**UNITED STATES OF AMERICA
NUCLEAR REGULATORY COMMISSION
Before the Atomic Safety and Licensing Board**

| In the Matter of |) | Docket No. 72-1050 |

DECLARATIONS AND CURRICULUM VITAE OF GORDON THOMPSON, PH.D.

Declaration of 12 November 2018
by Gordon R. Thompson
for submission to the
US Nuclear Regulatory Commission
regarding an application by
Interim Storage Partners LLC
for a license to construct and operate a
Consolidated Interim Storage Facility
in Andrews County, Texas

Figure V-1
Core Damage Frequency for Accidents at a Surry PWR Nuclear Power Plant, as
Estimated in the NRC Study NUREG-1150

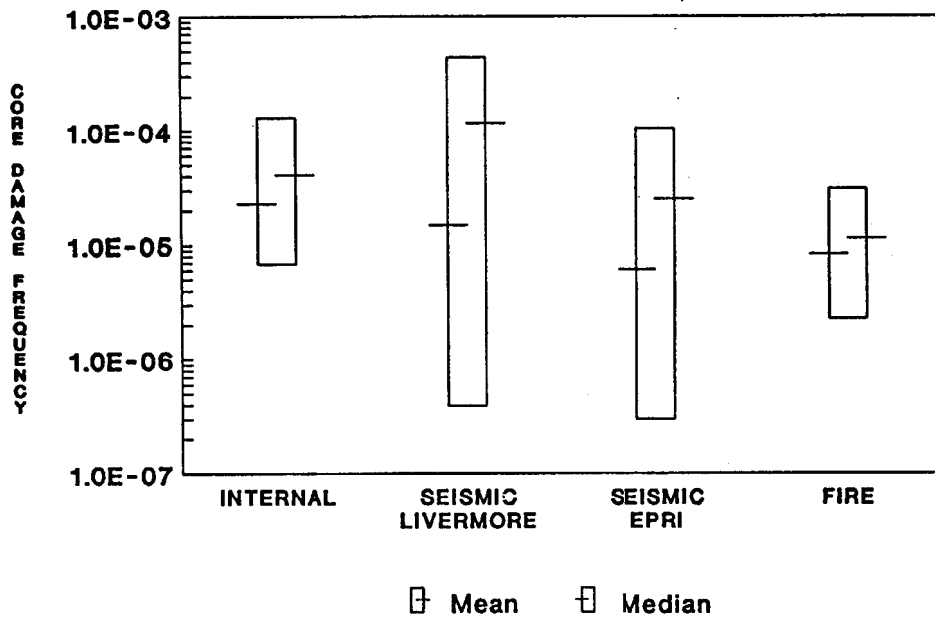
(V-5) Figures V-1 through V-3 show PRA findings for two commercial reactors – a pressurized-water reactor (PWR) at the Surry site, and a boiling-water reactor (BWR) at the Peach Bottom site. Figures V-1 and V-2 show the estimated probability of an accident involving substantial damage to the reactor core. Such damage would involve melting of some or all of the fuel in the core. The probability is expressed as core damage frequency (CDF) per reactor-year (RY). Figure V-3 shows the estimated conditional probability (i.e., probability given core damage) of various types of containment failure. A failure of containment would lead to a release of radioactive material to the atmosphere. The earlier the failure, the larger the release, other factors being equal.

Figure V-3
Conditional Probability of Containment Failure Following a Core-Damage Accident
at a Surry PWR or Peach Bottom BWR Nuclear Power Plant, as Estimated in the
NRC Study NUREG-1150

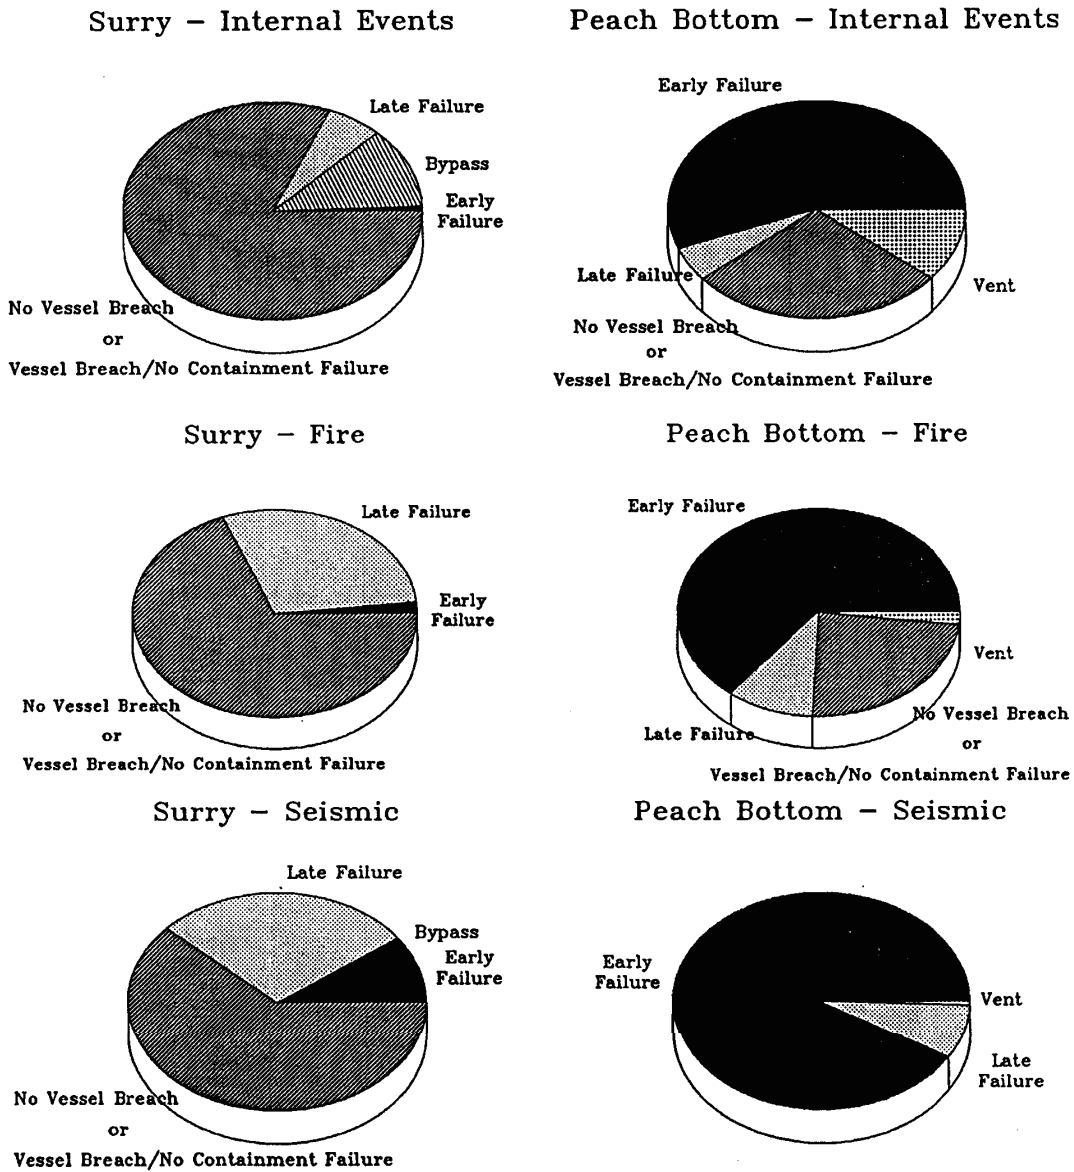
(V-25) Estimating the probability of core damage is just one step in assessing the radiological risk posed by a commercial reactor. Another step is to estimate the potential release of radioactive material to the environment. Figure V-3 illustrates a part of that step – estimating the conditional probability of failure of containment, given core damage. Additional steps include estimation of the movement of radioactive material in the environment, and estimation of the resulting consequences. As mentioned above, assessment of radiological risk involves the compiling of a set of qualitative and quantitative information about both probability and consequences.

Figure V-4
Contamination of Land in Japan by Radioactive Cesium Released to Atmosphere
During the Fukushima #1 Accident of 2011

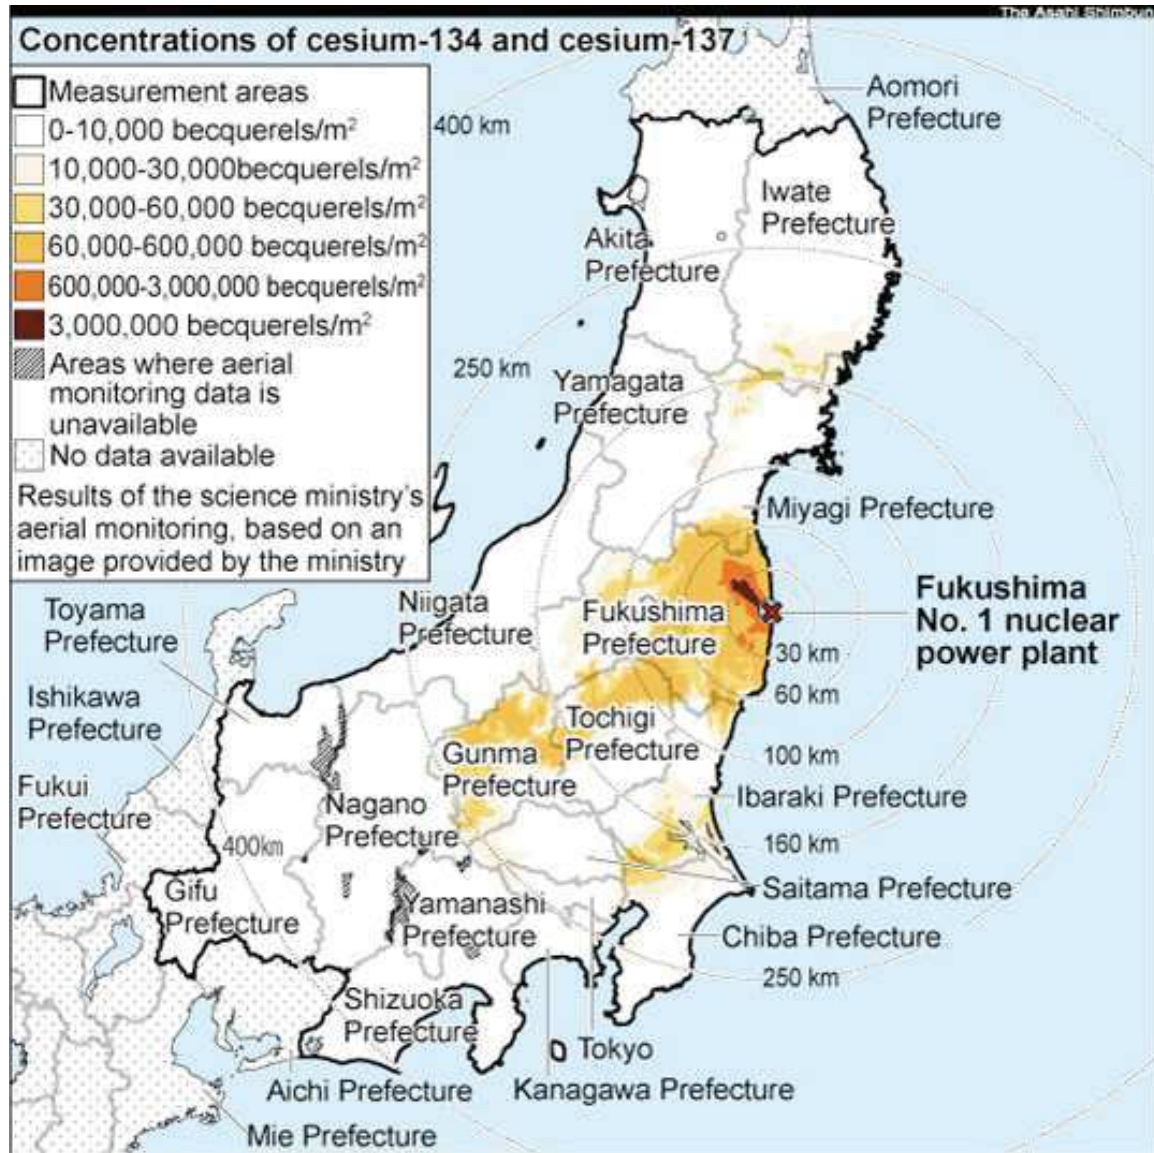
(X-50) Japan’s experience with fallout from the 2011 Fukushima accident is instructive. The pattern of radioactive fallout across Japan is complex, as shown in Figure V-4. That fallout contained about 6 PBq of Cs-137, as shown in Table V-1. This amount of Cs-137 is comparatively small in the context of a potential release from a pool fire. Yet, the impacts of the Fukushima fallout on Japan are diverse and significant. For example, it is reported that 160,000 people were displaced from land contaminated by the Fukushima accident, and about one-third of this population remains in temporary housing. There is considerable uncertainty about the number of people who may be able to return to their homes.¹³³ Also, all of Japan’s nuclear power plants remain shut down, due to public concern about their operation.

Figure V-5
Probability Distribution of Monetized Losses from Nuclear-Facility Incidents:
Sornette et al's Comparison of Empirical Data with PRA Estimates

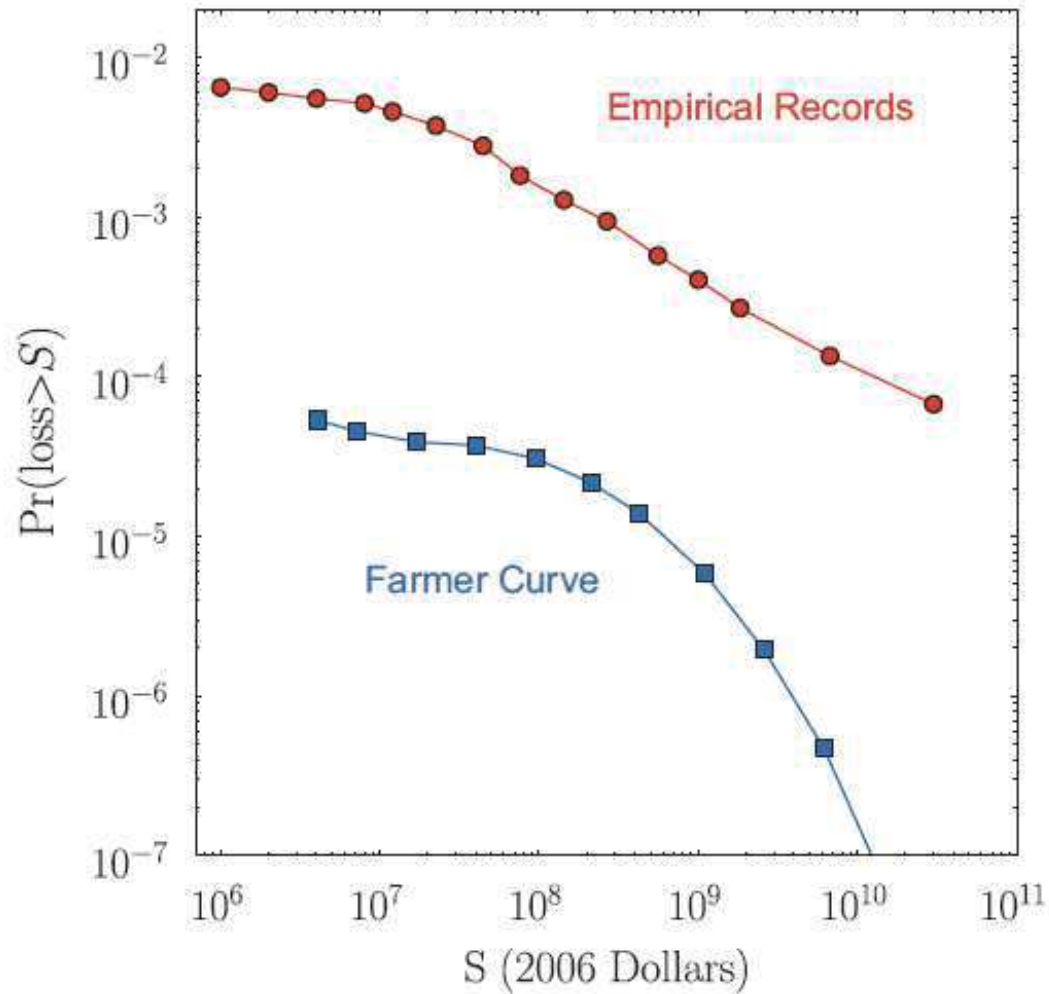
(V-27) A paper by Sornette et al reveals the limitations of PRA findings by comparing them with lessons from direct experience.³⁸ That paper accompanies this declaration as Exhibit #22. The paper considers monetized losses from nuclear-facility incidents, using two sources of information. One source is a reactor PRA. The other source is a compilation of data on actual incidents at nuclear facilities. Figure V-5 of this declaration reproduces a figure from Sornette et al. That figure shows that the PRA substantially under-estimates the probability of a monetized loss. The under-estimation grows as losses become larger. In other words, the PRA findings show a thin-tail probability distribution, whereas the empirical data show a fat-tail distribution.

Figure X-1
PWR Spent Fuel Storage Racks: Low-Density and High-Density Designs

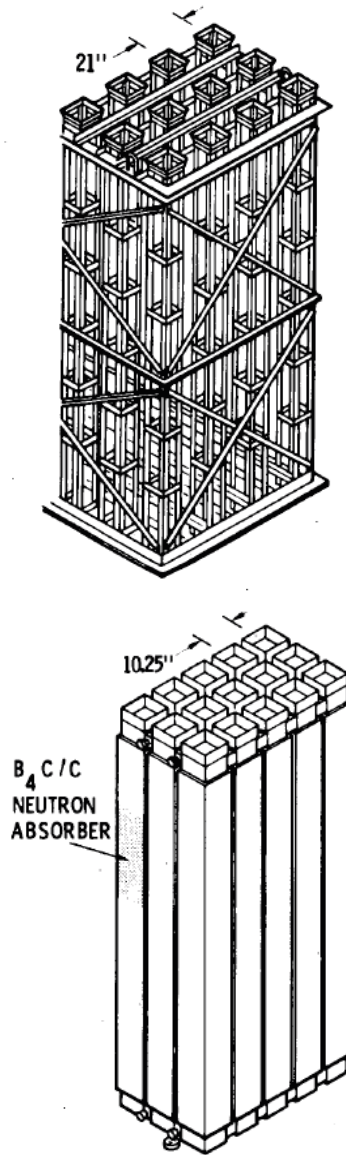
(X-8) As discussed in paragraph I-7, above, the pool serving each commercial reactor in the USA is now equipped with high-density, closed-frame racks. The nuclear industry began installing these racks in the 1970s, to replace the low-density, open-frame racks previously used. The high-density racks offered a comparatively cheap option for storing a growing nationwide inventory of spent fuel. Figure X-1 shows the configurations of the two types of rack.
